**revised environmental  
impact statement  
for the proposed  
PHYSICAL EDUCATION FACILITIES  
UNIVERSITY OF HAWAII  
MANOA CAMPUS**

**DAGS JOB NO. 02-31-1851.2**

**October 1977**

Figure 6  
 PROPOSED SITE SHOWING THE  
 QUARRY AREA AND  
 ROADWAY ENTRANCES/EXITS

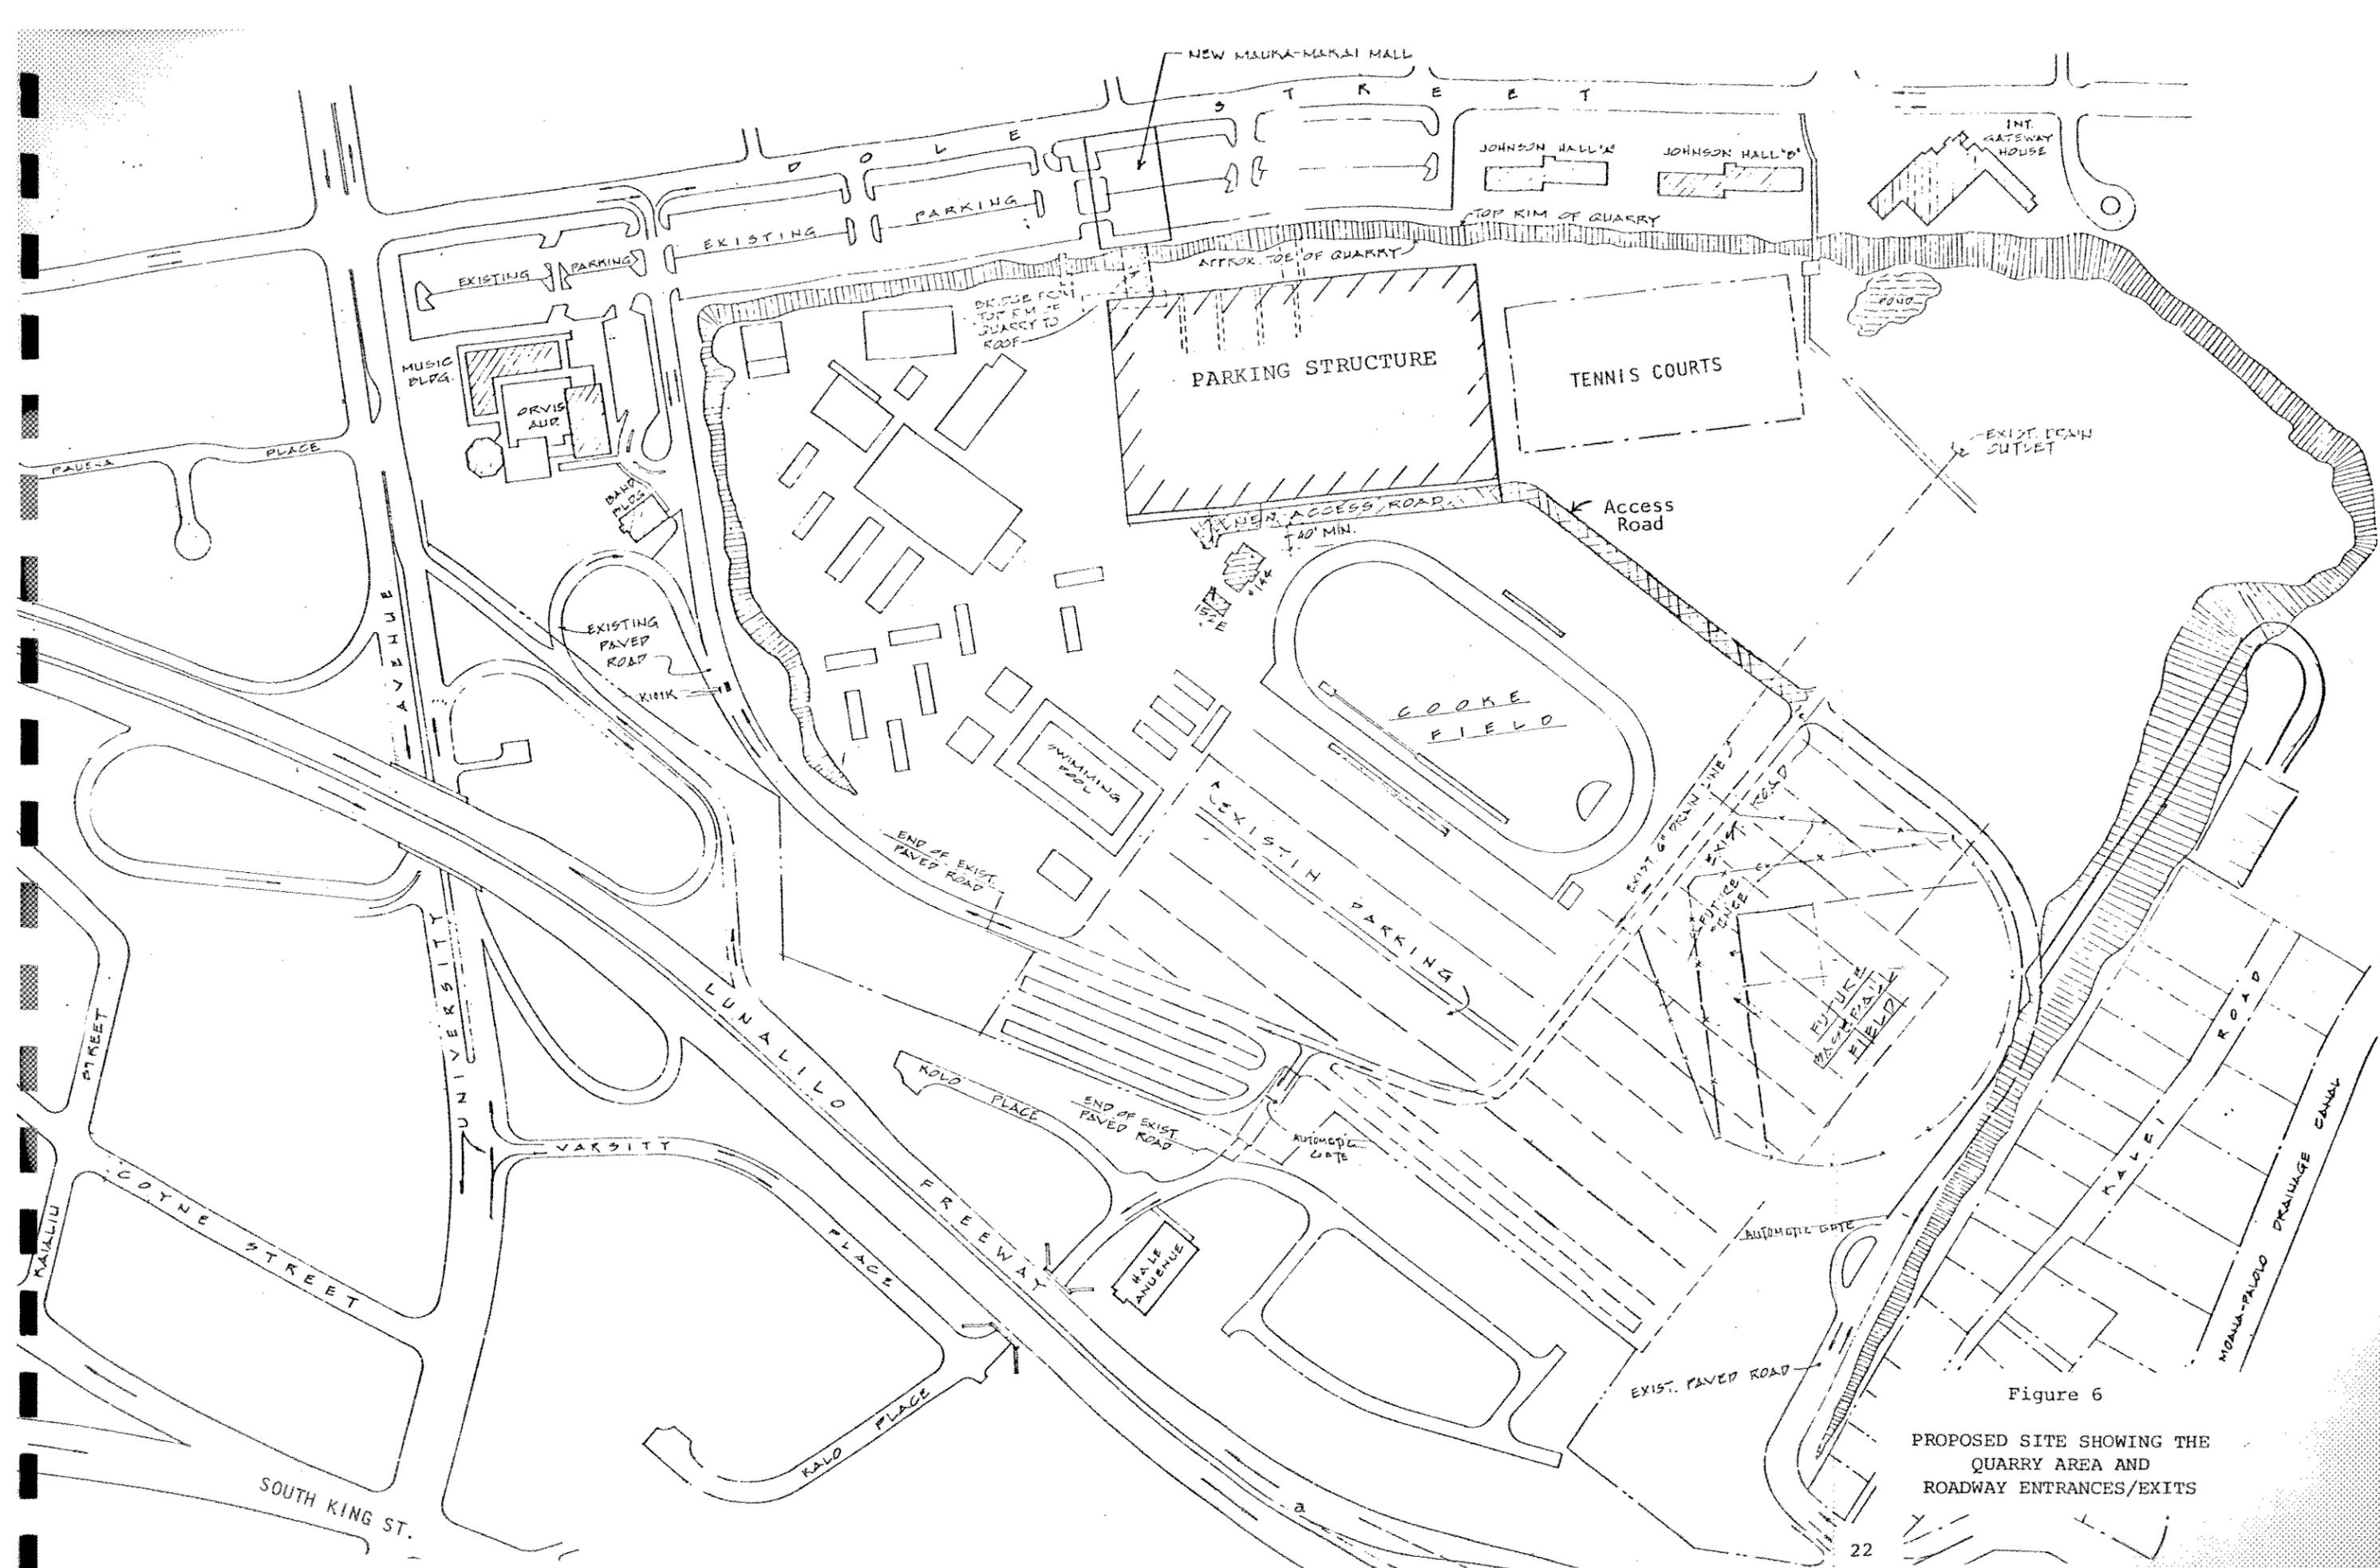
- 4) P.17. The citation under Phasing and Timing for Figure 6 appears incorrect. Perhaps the correct reference is for figure 4B.
- 5) P.20. The statement, "There is (sic) no stream or other water bodies in the immediate area of the project site (within the quarry)," is incorrect. There is a pond within the quarry, near the base of the cliff Gateway House.

5. Page 20. The statement on this page is incorrect and the pond, as pointed out in your comment and as shown on Figure 6, page 22, will be identified in the Revised Environmental Impact Statement.
6. The air pollution consultant has reviewed your comment on the air quality. His response on this subject is provided below:
